ACCESSIBILITY ASSESSMENT REPORT

Irrawang High School

Schools Infrastructure

DATE	REVISION	STATUS	AUTHOR	REVIEWED
21.10.2022	0	Draft – Schematic Design Access Report	BS	JH

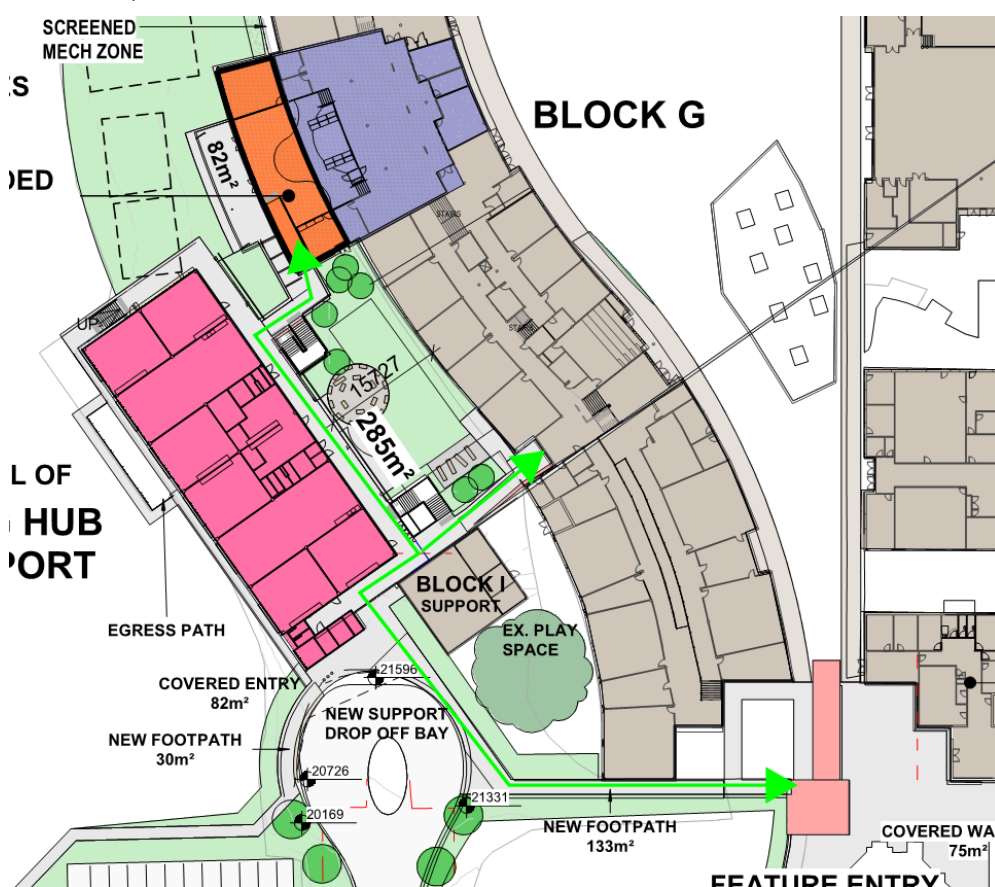
Comment: Details to be provided, it does not appear as though compliant access will be achieved from the allotment boundary based on the current design notwithstanding a compliant accessway will be provided from the new feature entry, drop off area to the new buildings. On the basis of the proposed arrangement and location of the drop off area it is proposed to rationalise the omission of access from the allotment boundary.

Comment: Details to be provided, all new buildings are to be connected with compliant accessways as shown below. Architect to ensure compliance details demonstrating compliance to be provided with the DD phase.

Figure 5: Designated Set Down Area

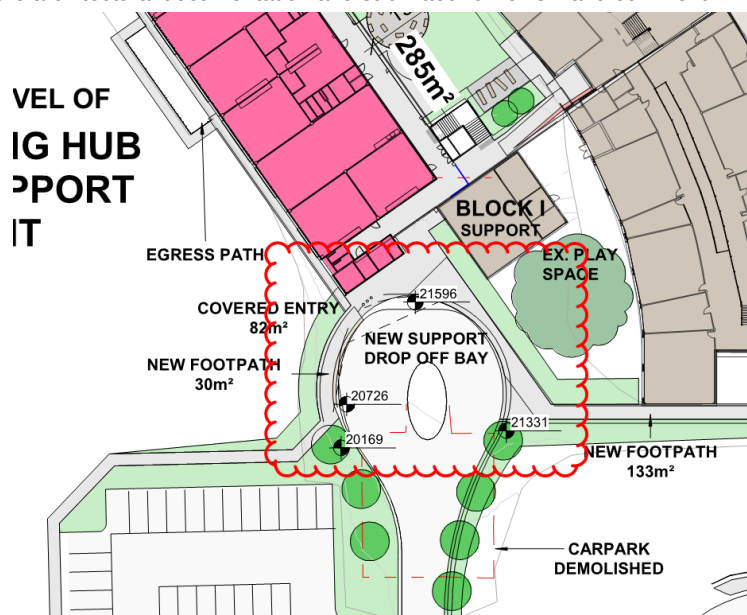
It is understood that a new drop off area is being proposed as shown below as noted earlier in this report a compliant set down area is to be provided in accordance with AS1428.4.1

Compliance is readily achieved, details demonstrating compliance with the above will need to be shown on the architectural documentation and submitted for review and comment in DD.

Figure 15: Learning Hub – Typical Circulation Spaces

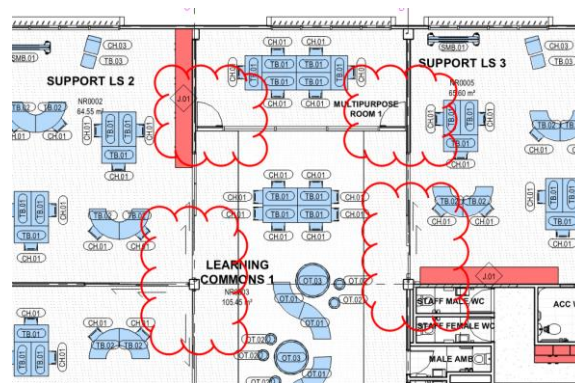
Circulation space does not comply in a number of locations typical examples as shown in the figures below. Circulation space to be reviewed as part of the DD phase, with doors being relocation adjusted and or furthermore consideration being given to address by way of a Performance solution will need to be confirmed.

Compliance can be achieved with door location adjustment. Sliding door handles can be offset or nib type walls incorporated. To be updated as part of DD phase and or documented as a Performance Solution.

Figure 36: Block G – Platform Lift

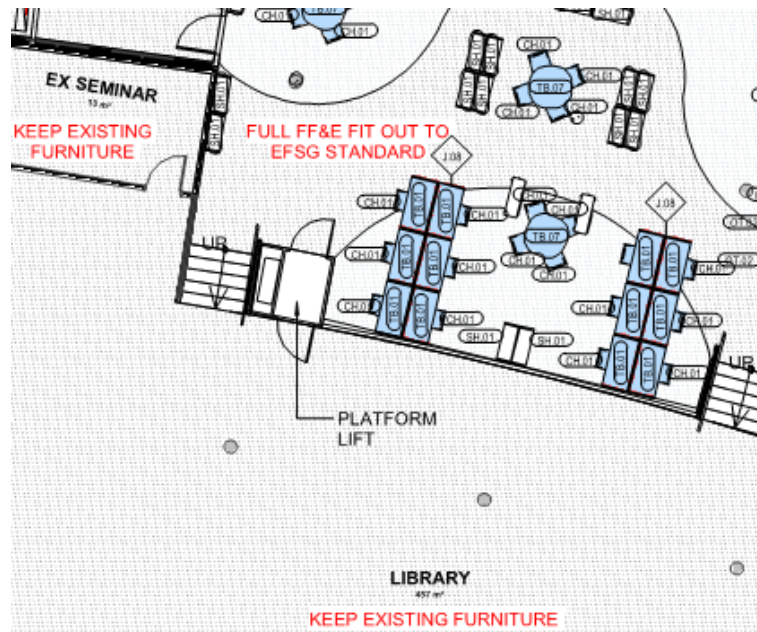
In addition to the above, it is also noted that a platform lift is proposed within the library to provide access between the split levels. The total distance travelled cannot be more than 1000mm to achieve minimum compliance with the BCA

Figure 38: Gymnasium Accessible WC

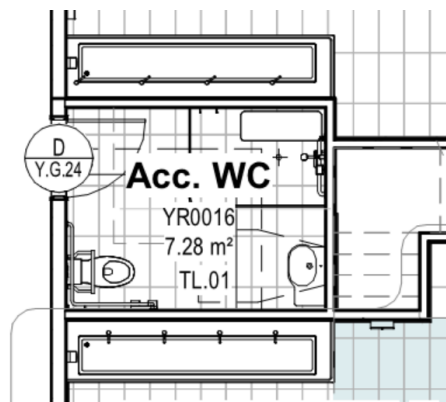
Details demonstrating compliance will need to be provided along with the DD phase, spatially we note that the current size of compartments could readily comply however minimal tolerances within the design however compliance is readily achievable through further design development. (see typical example below)

Accessible showers shall comply with AS1428.1 including fixed chair and shower fittings. Spatially we note that the current size of the compartment could readily comply details demonstrating compliance will need to be provided along with the DD phase.

Figure 43: Ambulant Clearance Width

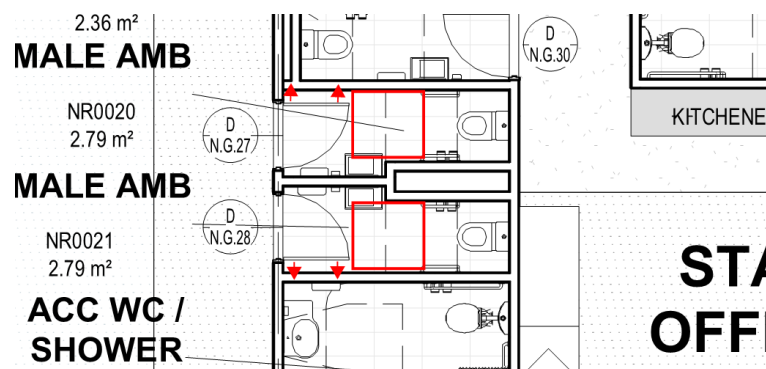
Spatially we note that the current size of the ambulant facilities could readily comply however minimal tolerances are available through further design development. (See typical example below)

Whilst we note that there are some coordination items with respect circulation space which will be further coordinated during the DD phase. In addition to the above, having regards to the required ambulant facilities we note that there are minor encroachments on the required circulation space this will need to be resolved through the DD phase. details demonstrating compliance will need to be provided along with the DD phase.

Figure 44: Non-compliant Accessible Adult Change Facility

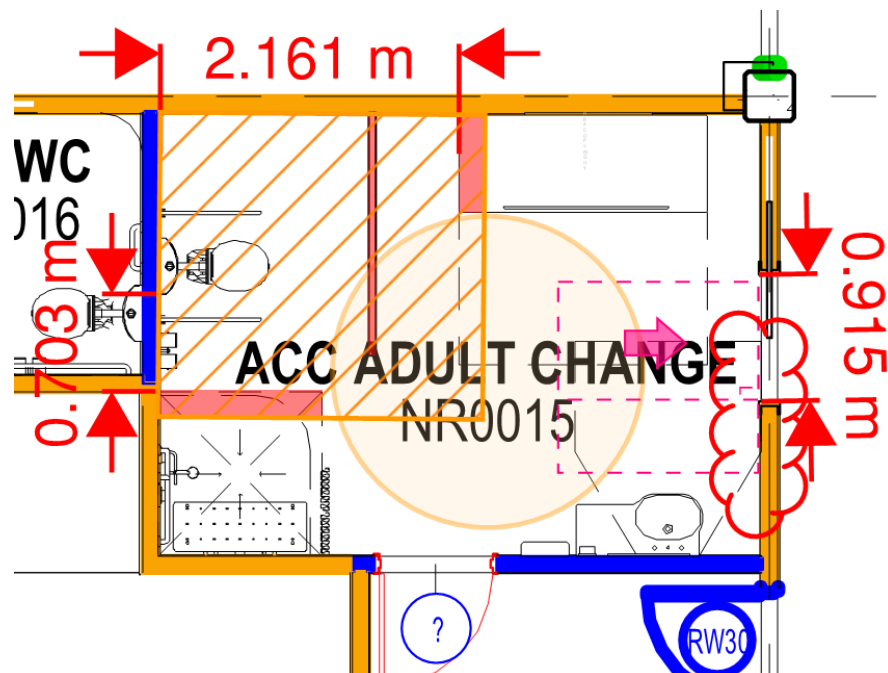
As seen in Figure 44, the required circulation space to be provided to the closet pan of the facility is impeded in multiple locations by the adjacent shower and change table. Additionally, there appears to be privacy screen serving the pan, it is not clear how this system complies with the required circulation space of the compartment. Provide further detail of compliance at DD stage.

A changing rail is required to be installed adjacent to the wash basin, indicated by the red cloud in the figure above. The installation of the changing rail is to be in accordance with Figure 2 and Clause 8 of Specification F2.9 and will therefore impede on the circulation space/clearance width of the sliding door as currently documented.
